8. COA-055578-2019

Commission of
Architectural Review

STAFF REPORT

Rehabilitate an existing single family home.

Figure 4. Remnants of shed in rear yard

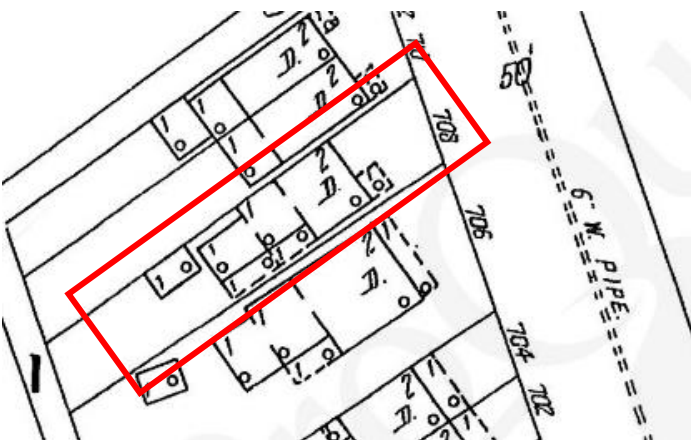
- The applicant is proposing to rehabilitate a two-story frame Greek Revival home in the Union Hill City Old and Historic District.
- The applicant proposes to complete the following work:
 - Replace the metal front porch columns with square wood columns and Richmond rail
 - Remove the metal awnings on porch and windows
 - Rebuild the existing box gutters
 - Replace all roofs with standing seam metal
 - Remove the existing chimney
 - Replace all windows with simulated divided light windows
 - Remove window openings on the side and rear of the home
 - Remove and rebuild the rear one-story addition, maintaining the existing roof
 - Install a metal door in the rear entry
 - Construct a rear stoop of pressure-treated wood
- On a site visit to the property staff observed that a shed in the rear yard has recently been demolished.
